SITE CHARACTERIZATION REPORT - HYDROLOGIC CHARACTERIZATION

**HYDE PARK LANDFILL SITE
TOWN OF NIAGARA, NEW YORK**

APPENDIX C - RESPONSES TO AGENCY COMMENTS

**Prepared For:
Miller Springs Remediation Management, Inc.**

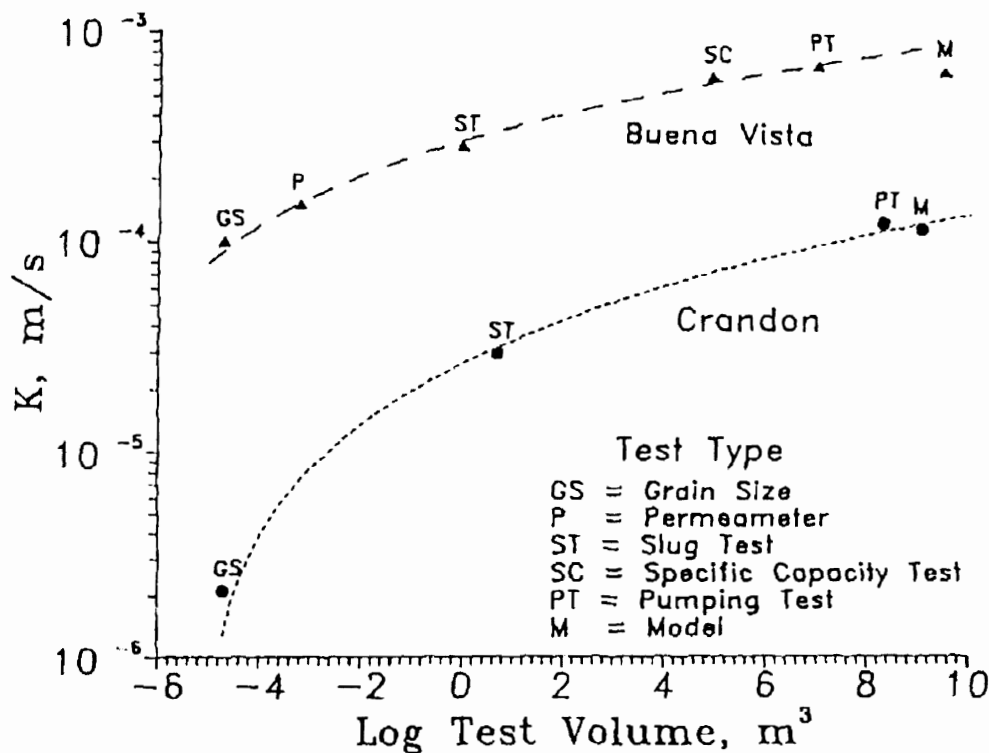
14. Section 3.1.2. Bedrock, page 10, second paragraph. *Figure 3-1 presents a cross section of the fracture zones, with "A" daylighting at the gorge face. EPA recommends including a photograph of gorge face where A-A' meets the gorge. The fracture zones that daylight at the gorge should also be presented.*

The SCR-G includes a photograph, Figure 4.5, on which the position of "A" can be located.

figure 3-11
TRANSMISSIVITY DISTRIBUTION IN FZ-01
SITE CHARACTERIZATION REPORT
HYDE PARK LANDFILL SITE
Town of Niagara, New York

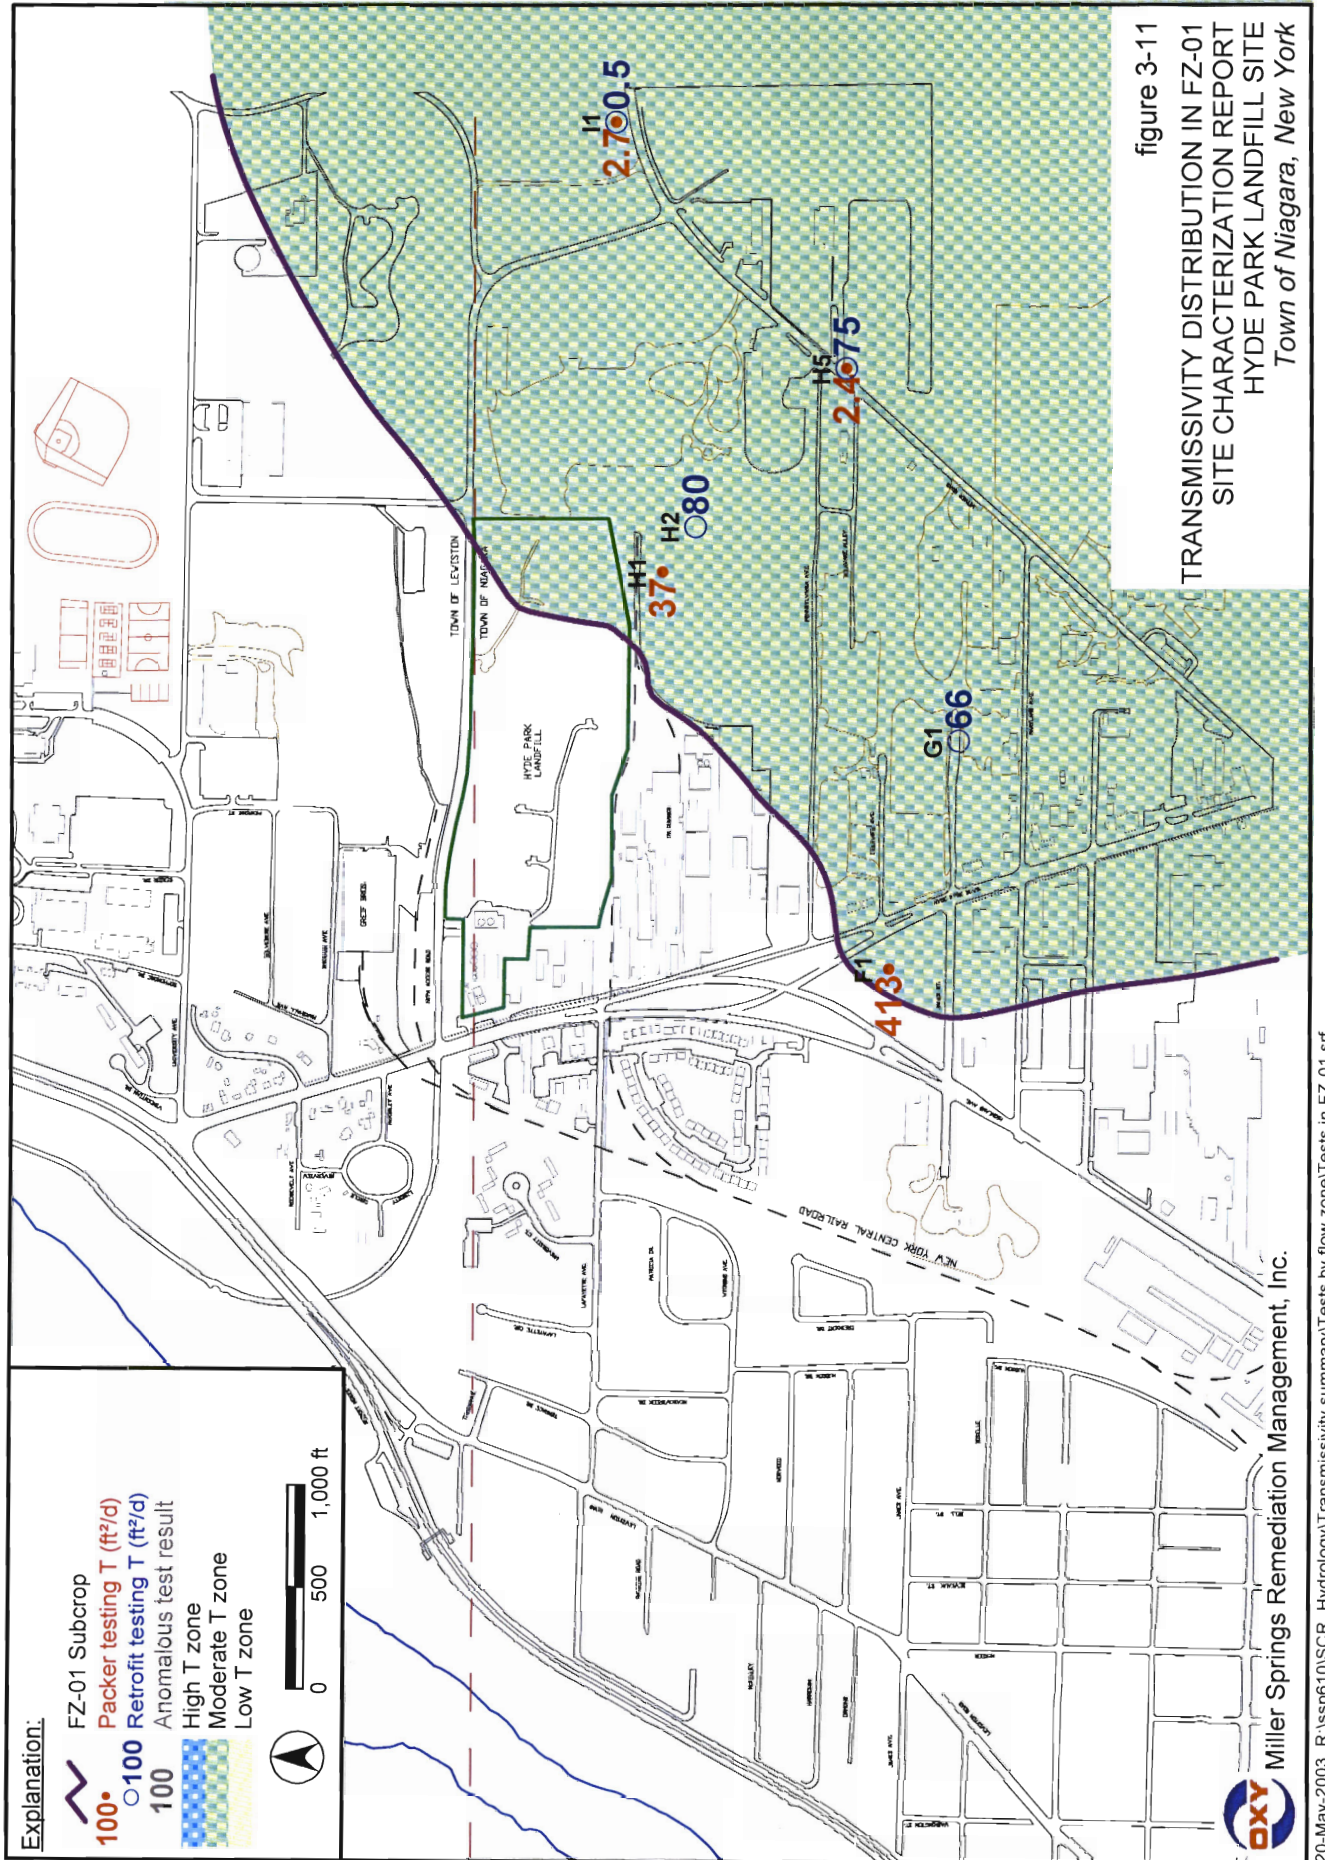
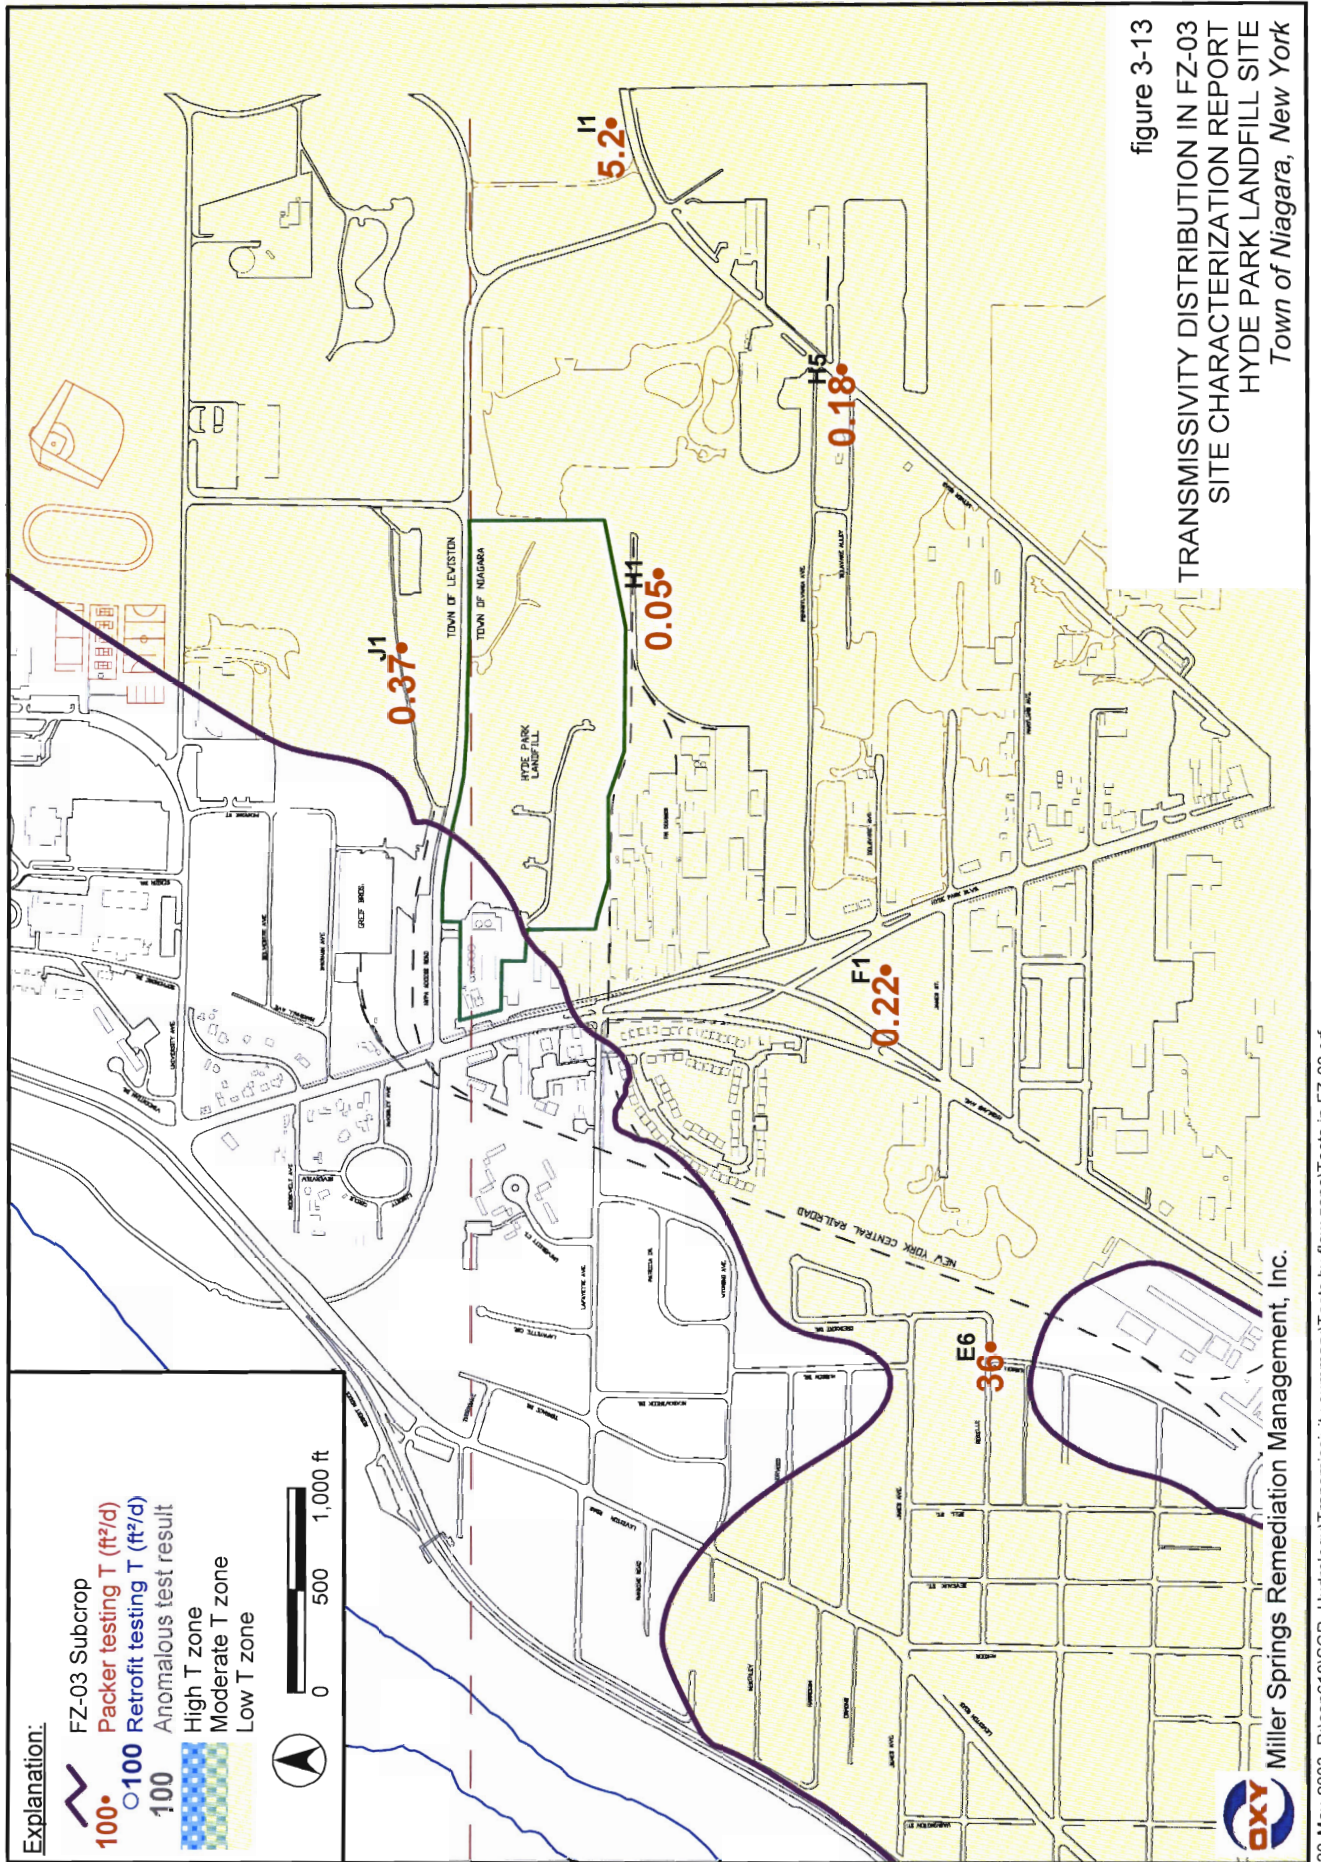
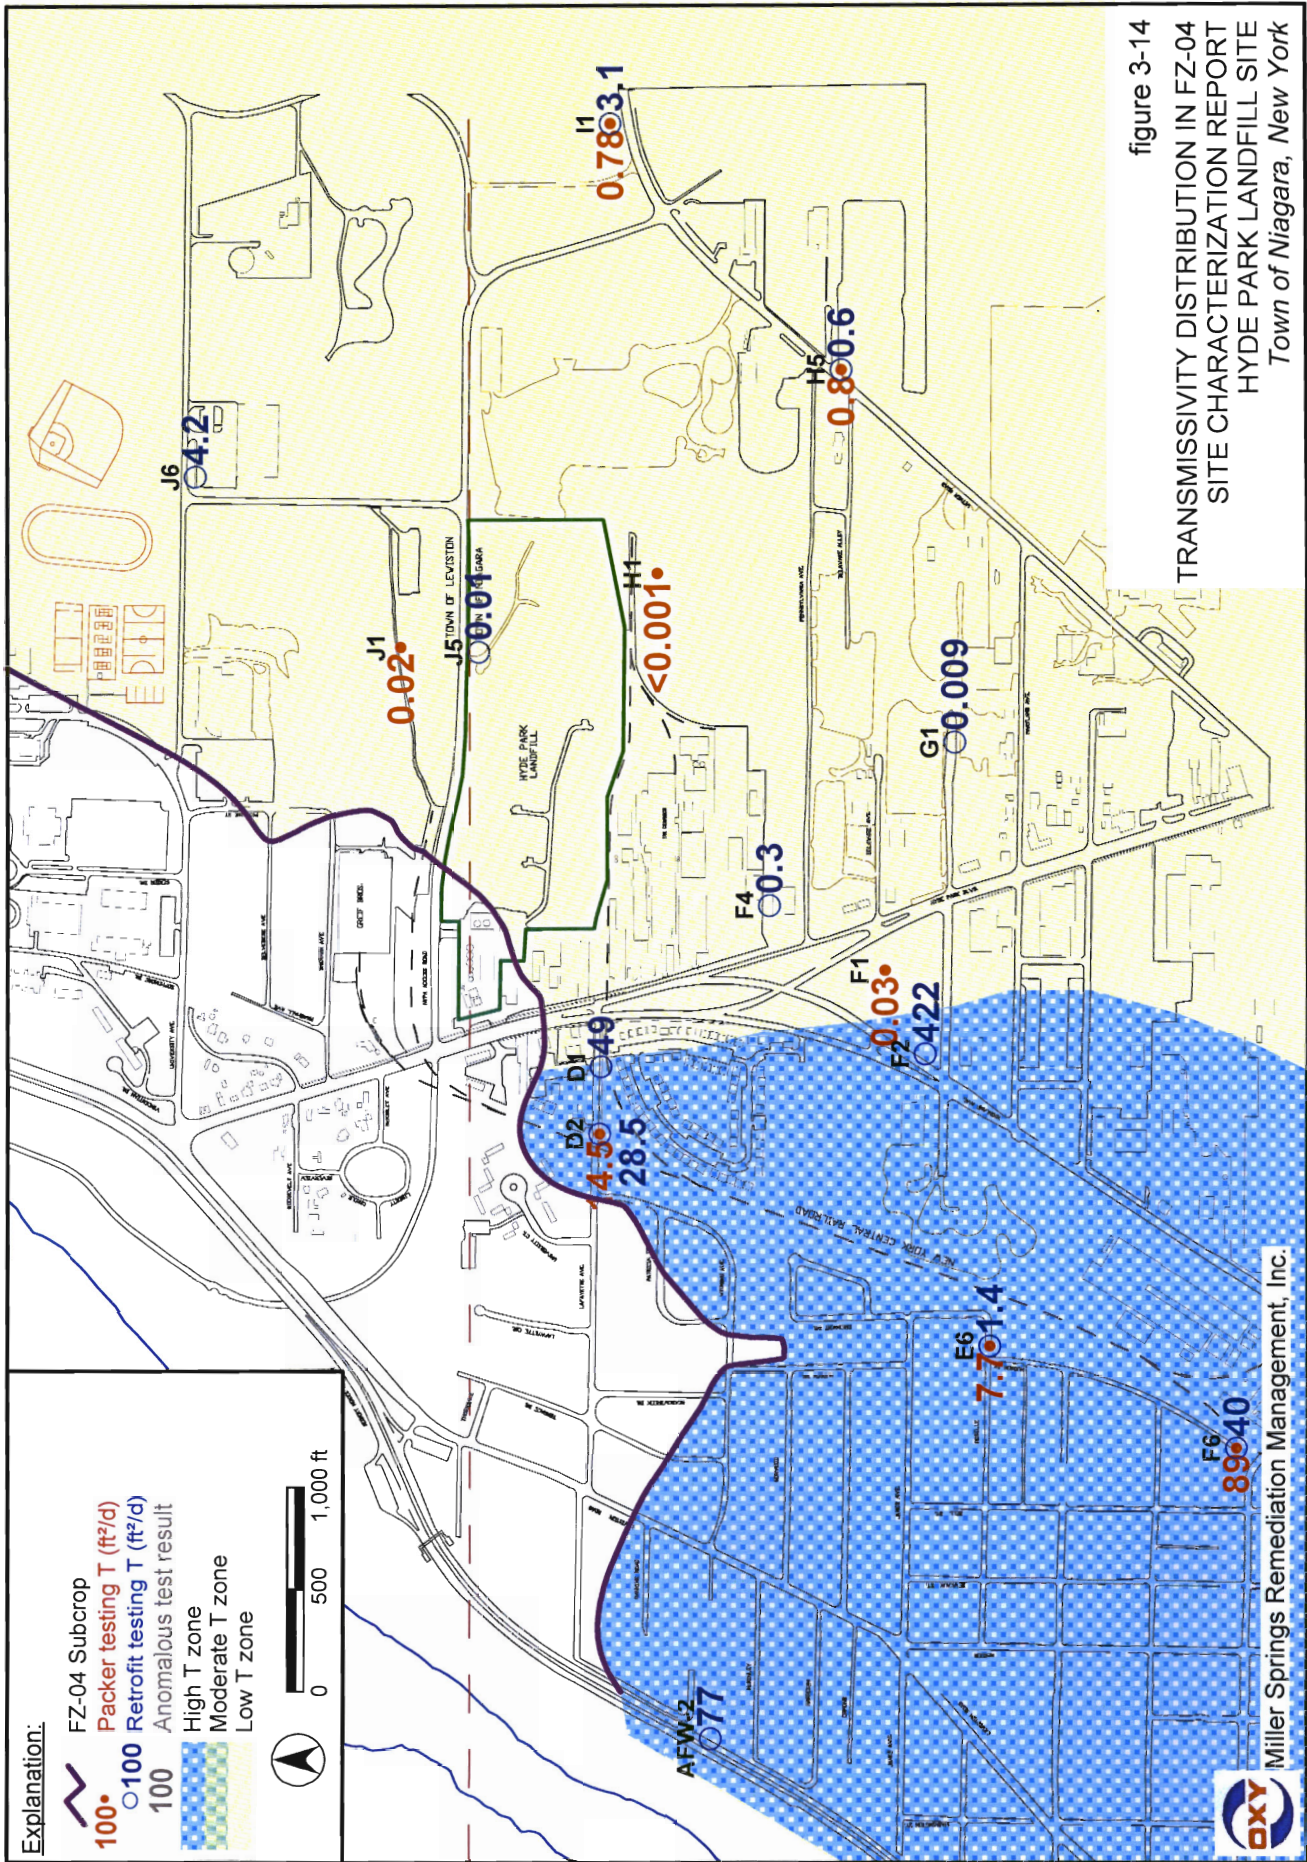
52. Figures 3-11 through 3-21. General comment: various transmissivity values are incorrect in comparison with the values presented in Appendix A. Please check values and edit.

The problem with Figure 3-12 was identified in our review of the final document. We apologize for the errors. All tables and figures have been checked. In some cases, the values indicated on the figures have been modified slightly to be absolutely consistent with the values provided in the tables. We are submitting a revised set of transmissivity maps, Figures 3-13 to 3-21, with these responses.

See the response to Comment S1.
